UNITED STATES PATENT AND TRADEMARK OFFICE

APPLICATION NO.	FILING DATE	FIRST NAMED INVENTOR	ATTORNEY DOCKET NO.	CONFIRMATION NO.
10/694,851	10/29/2003	Terrance N. Durdon	2077-41	6267

Office Action Summary

DETAILED ACTION

REPLACEMENT SHEET

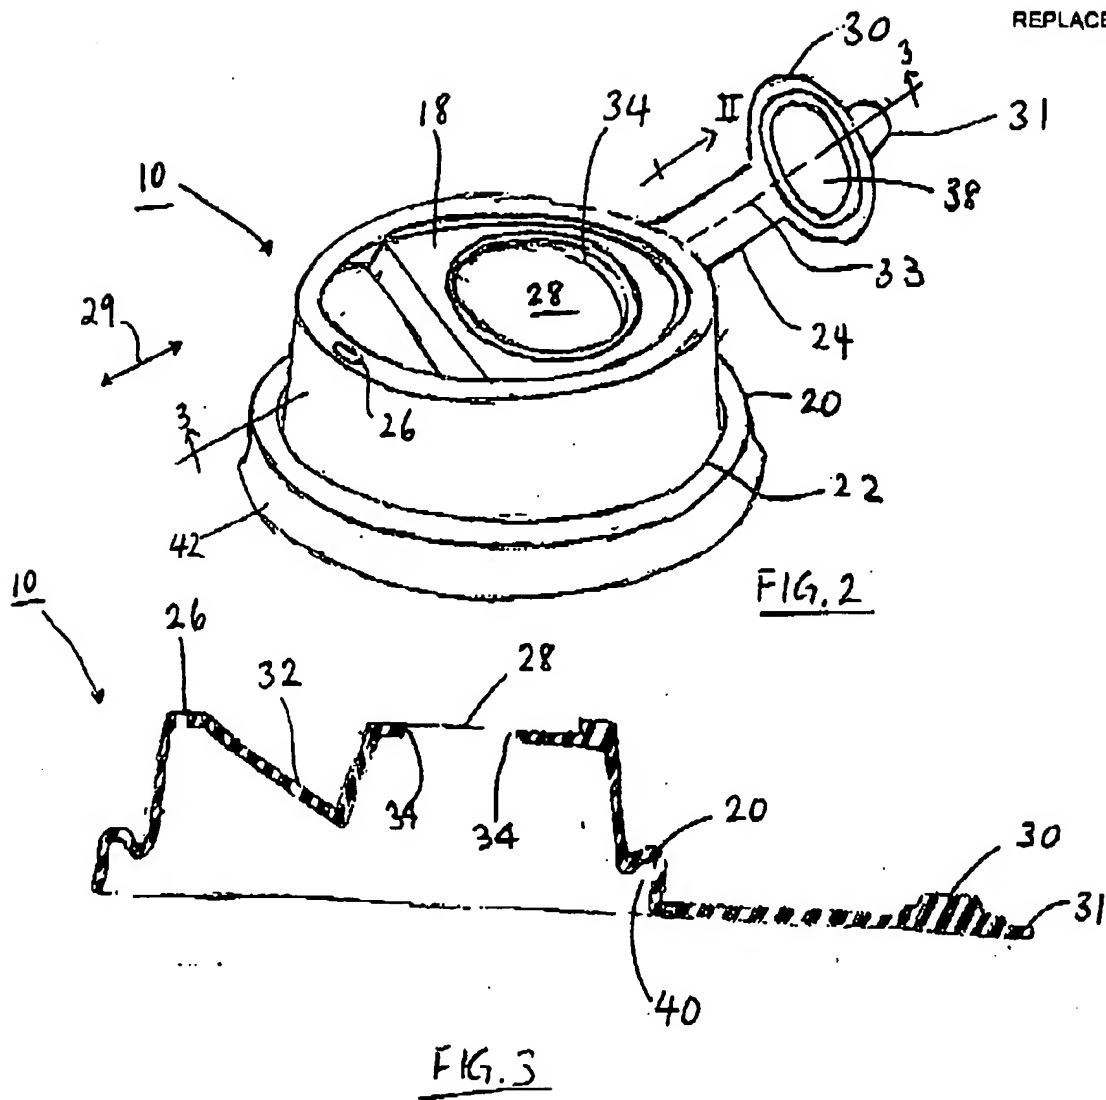
2. The drawings were received on September 28, 2005. These drawings are not approved as they introduce new matter. Since drinking opening **28** is not described as having an upstanding wall portion on only one side thereof (see the right side of the opening in figure 3), the proposed drawing correction introduces new matter as illustrating opposed ribs lying in the same plane without a corresponding upstanding wall portion surrounding the opening.
3. The drawings are objected to under 37 CFR 1.83(a). The drawings must show every feature of the invention specified in the claims. Therefore, the stiffening ribs and the cover portion and rim portion lying "substantially in the same plane" must be shown or the features canceled from the claims. No new matter should be entered.

4. The drawings are objected to because the cross hatching of figure 3 depicts a rubber material. See MPEP 608.02. Additionally, in figure 1, the lead line of reference character **12** appears to be pointing to a portion of the lid and not the cup rim as set forth in the specification. Corrected drawing sheets in compliance with 37 CFR 1.121(d) are required in reply to the Office action to avoid abandonment of the application. Any amended replacement drawing sheet should include all of the figures appearing on the immediate prior version of the sheet, even if only one figure is being amended. The figure or figure number of an amended drawing should not be labeled as "amended." If a drawing figure is to be canceled, the appropriate figure must be removed from the replacement sheet, and where necessary, the remaining figures must be renumbered and appropriate changes made to the brief description of the several views of the drawings for consistency. Additional replacement sheets may be necessary to show the renumbering of the remaining figures. Each drawing sheet submitted after the filing date of an application must be labeled in the top margin as either "Replacement Sheet" or "New Sheet" pursuant to 37 CFR 1.121(d). If the changes are not accepted by the examiner, the applicant will be notified and informed of any required corrective action in the next Office action. The objection to the drawings will not be held in abeyance.

Regarding the drawings, several claimed features are not seen in the figures. The plurality of ribs represented by **34** are not seen in the figures. Only one rib is seen in each of figures 2,3,7, and 8. The drawing correction submitted September 28, 2005 attempt to show a plurality of ribs. However, since the opening is not described as having an upstanding portion on only one side thereof (see the right side of the opening in figure 3), the corrected drawing

introduces new matter as illustrating opposed ribs lying in the same plane without a corresponding upstanding wall portion surrounding the opening

The stiffening ribs and the cover portion and rim portion lying “substantially in the same plane” in any of the figures including figures 7 and 8. Because figures 7 and 8 are not cross sectional views, there is no way to determine the claimed element lie “substantially in the same plane”. Moreover, since the cover portion **18** is recessed from the rim **20** it is unclear how at least these two elements lie “substantially in the same plane”.

not approved

Corrected drawing sheets in compliance with 37 CFR 1.121(d) are required in reply to the Office action to avoid abandonment of the application. Any amended replacement drawing sheet should include all of the figures appearing on the immediate prior version of the sheet, even if only one figure is being amended. The figure or figure number of an amended drawing should not be labeled as "amended." If a drawing figure is to be canceled, the appropriate figure must be removed from the replacement sheet, and where necessary, the remaining figures must be renumbered and appropriate changes made to the brief description of the several views of the drawings for consistency. Additional replacement sheets may be necessary to show the
